From: John Adams <jeadams60@gmail.com>
Sent: Saturday, March 3, 2018 12:55 PM
To: Mattingly, Laura L
Cc: Teri Adams; dougflaherty@twc.com
Subject: Case 17zone1049L
Attachments: img20180303_12532076.pdf

We are concerned about the hazards of the proposed entrances to the new facility at the corner of Bardstown Road and Watterson trail.

ENTRANCES AND PROBLEMS:

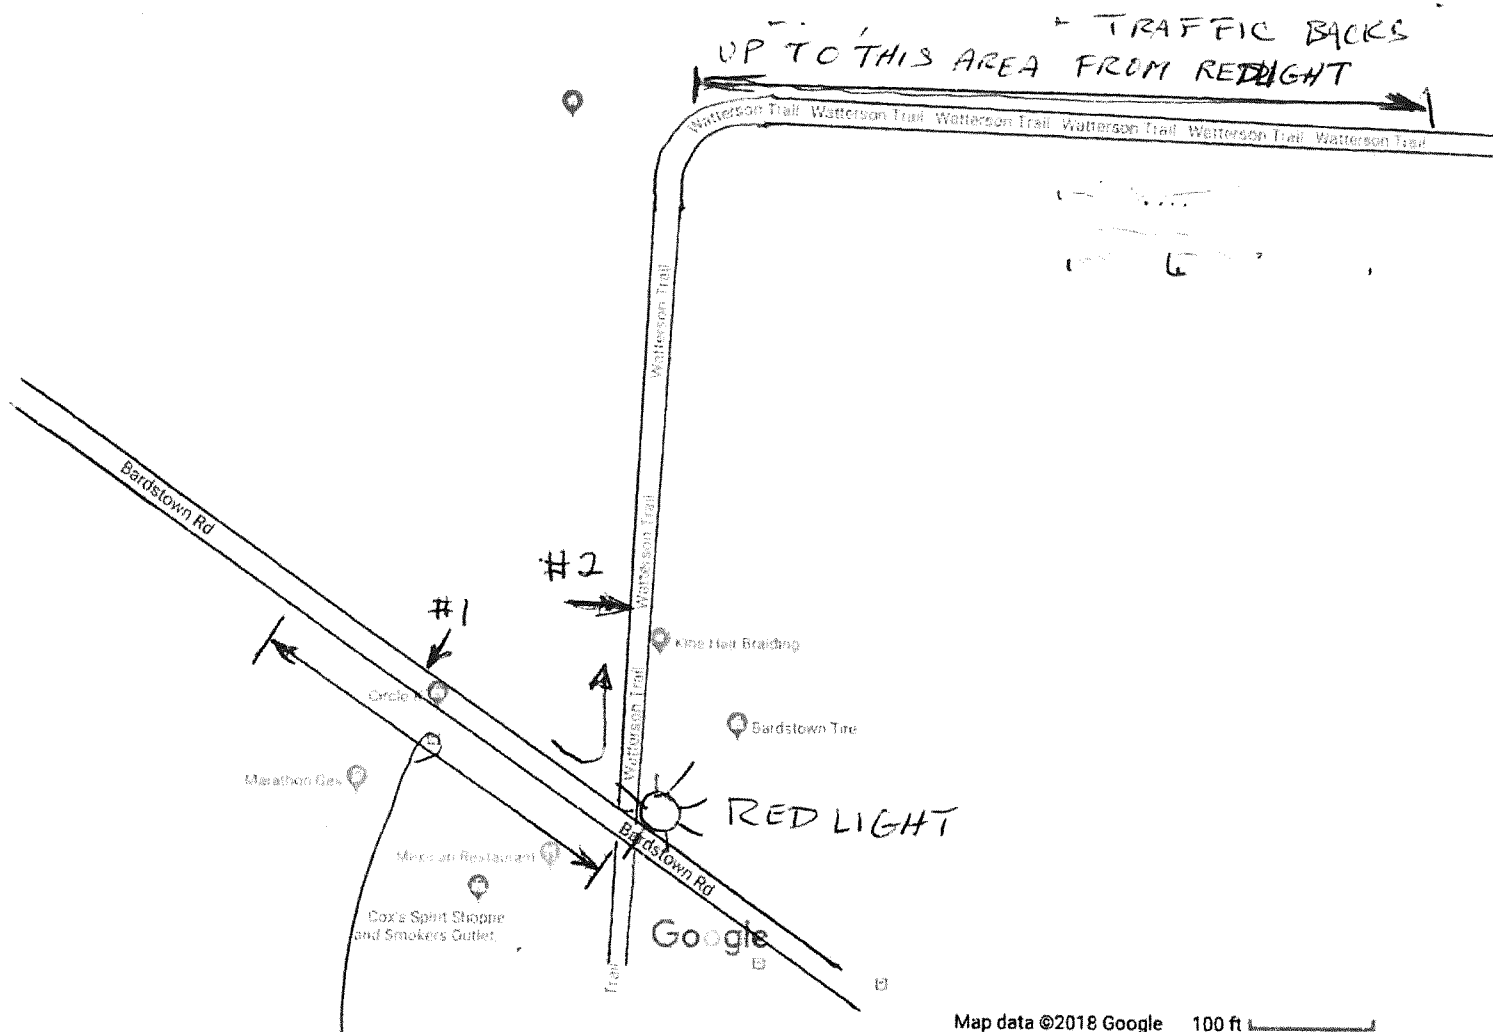
#1 PEOPLE HAVE WRECKS TRYING TO GET ACROSS THIS LANE

#2 IF SOMEONE WANTS TO ENTER THIS ENTRANCE, THE TURNING TRAFFIC OFF OF B-TOWN RD ONTO WATERSON TRAIL WILL CAUSE A BACKUP THROUGH THE LIGHT, AND RESULT IN GRIDLOCK
